Solar Wind Around Pluto
SWAP

New Horizons SWAP Data Sets Delta Review

0x586 Histogram Data

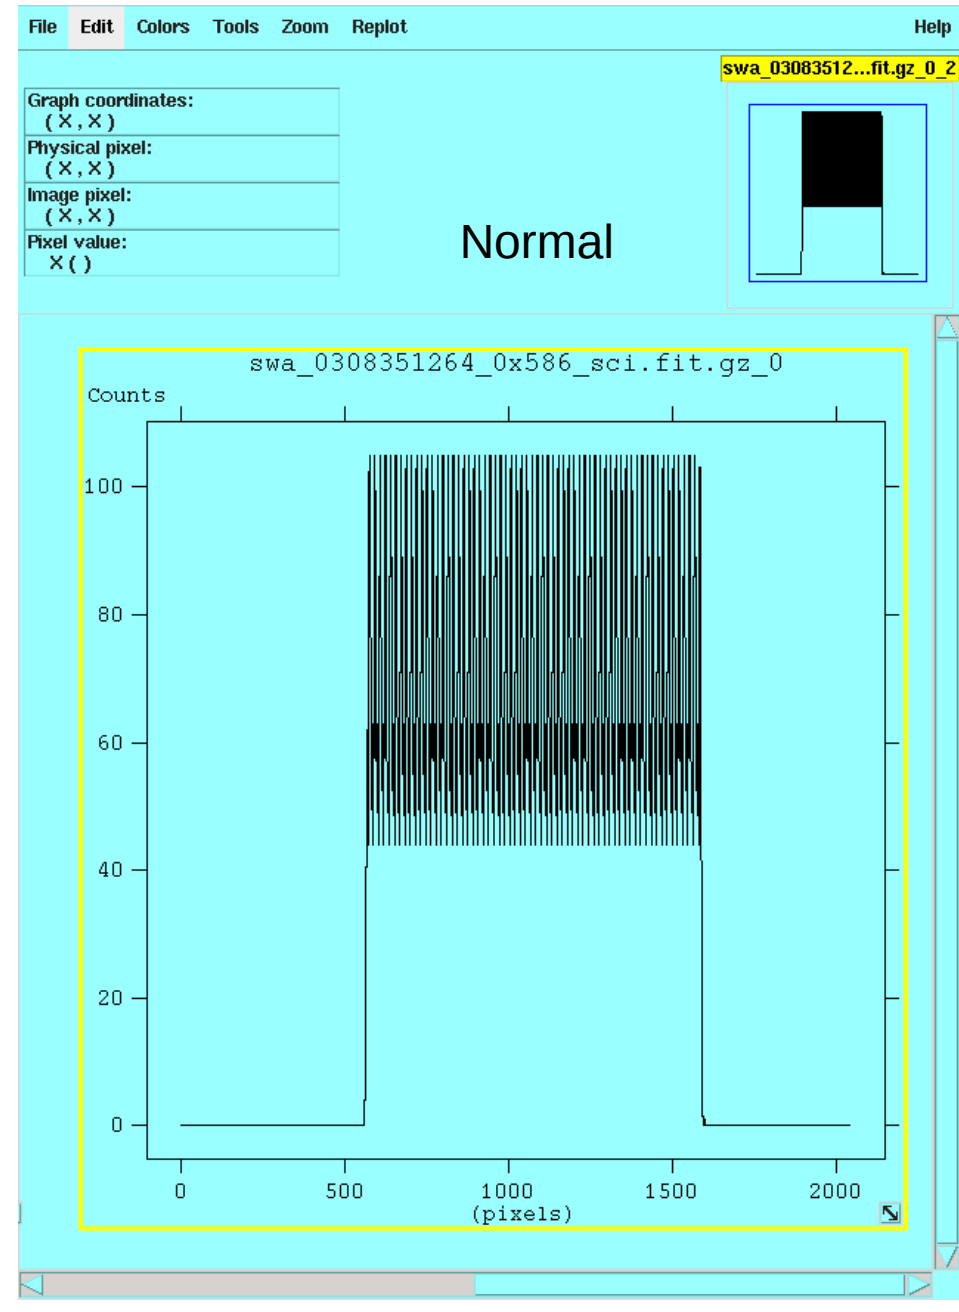
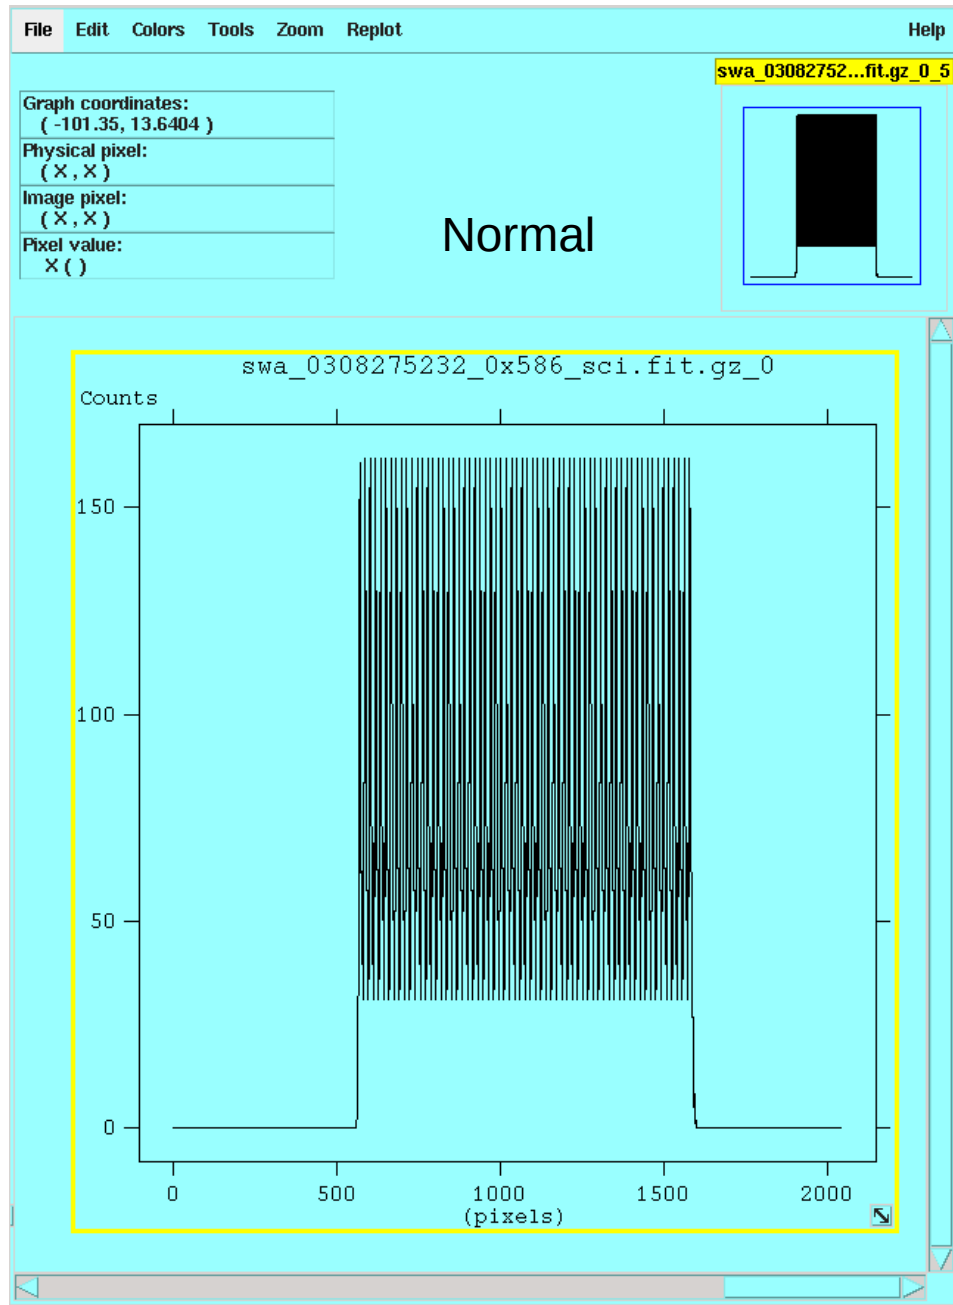
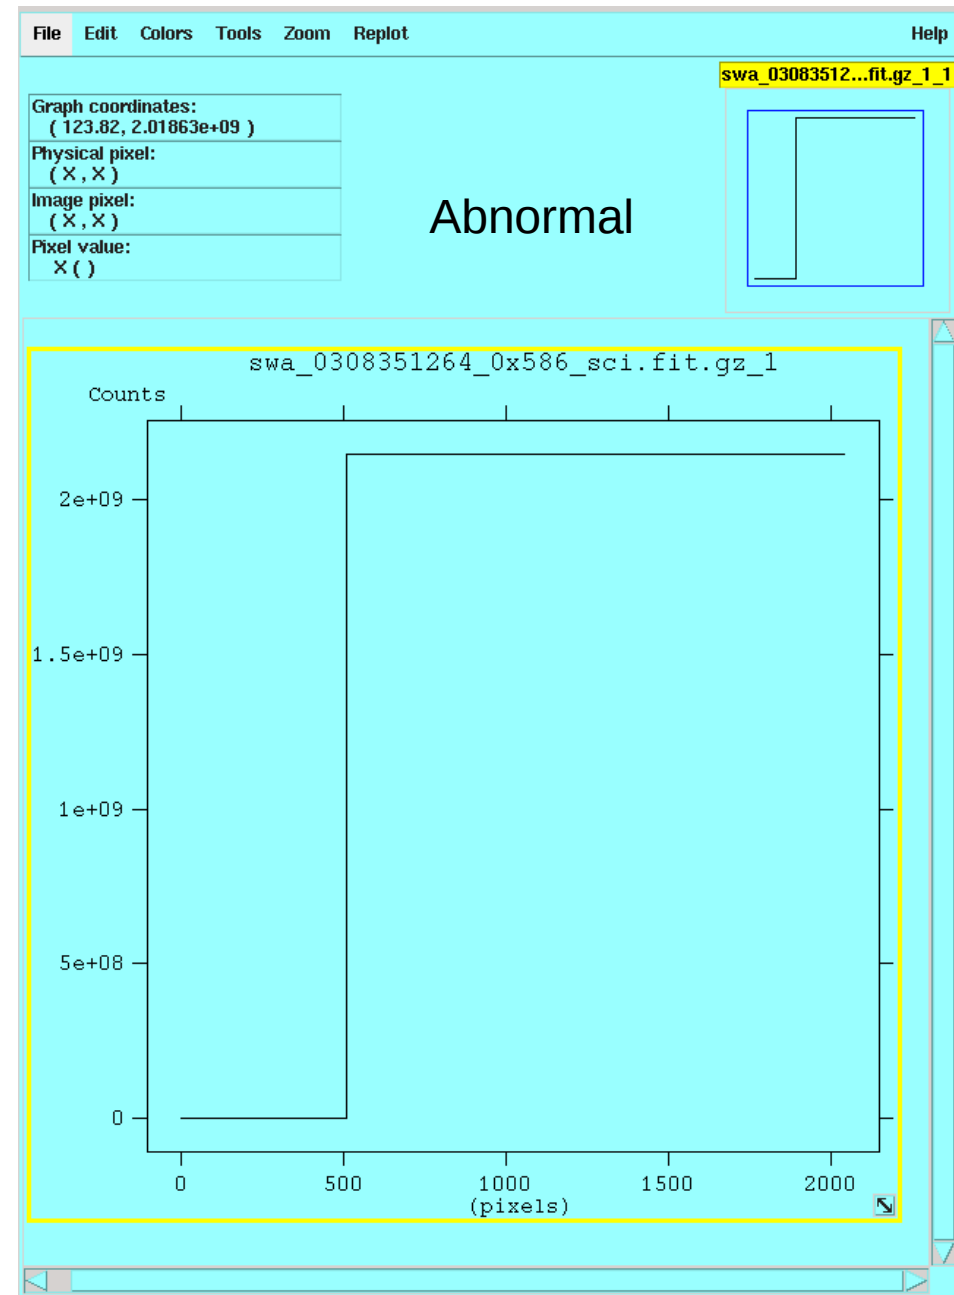
The new information in the swap.cat file describing the Histogram data format is adequate to understand the Histogram data. However, the processed 0x586 data shows an issue. This is described in the next 5 slides.

High-Value
Does Not
Seem Correct

More High-values Observed

Number Histogram
Seems Unaffected
(Primary HDU)

There are limited bad FITs data files in the 0x586 data set; however, the amount is not exorbitant. There could be many reasons why these files show unreasonable values for the Histogram and the investigators should review the 0x586 data to determine the source and fix the issue if at all possible. The issue does not influence the rest of the data which is a scientifically valid product. Thus, I would recommend removing these bad data files from the archive and then releasing these data to the public.
